SAM G51 Series Family Silicon Errata and Data Sheet Clarification

Data Sheet Clarifications

The following typographic corrections and clarifications are to be noted for the latest version of the device data sheet (Atmel-11209D-ATARM-SAM-G51G-SAMG-51N-Datasheet_19-Nov-14).

4. Module: Transmitter Operations

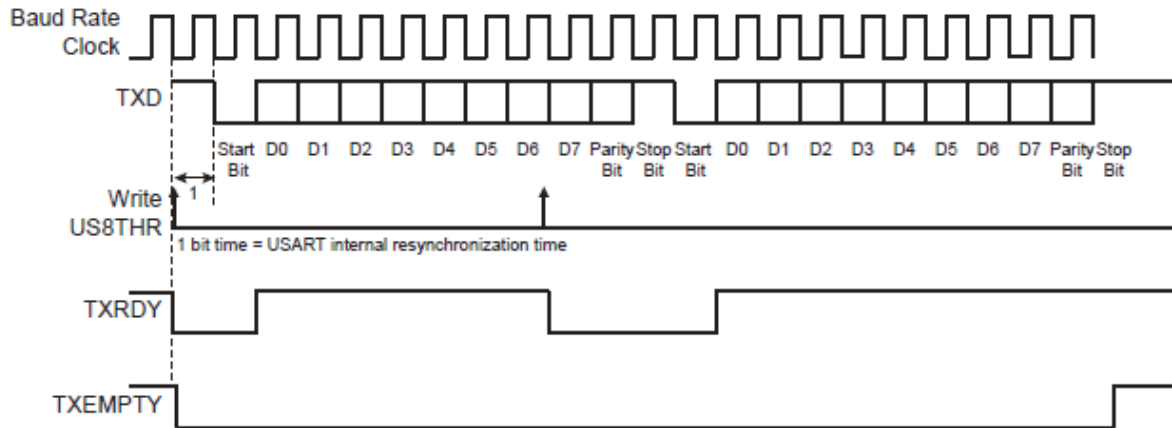
Figure 31-5 is incorrect and the corrected figure is as follows:
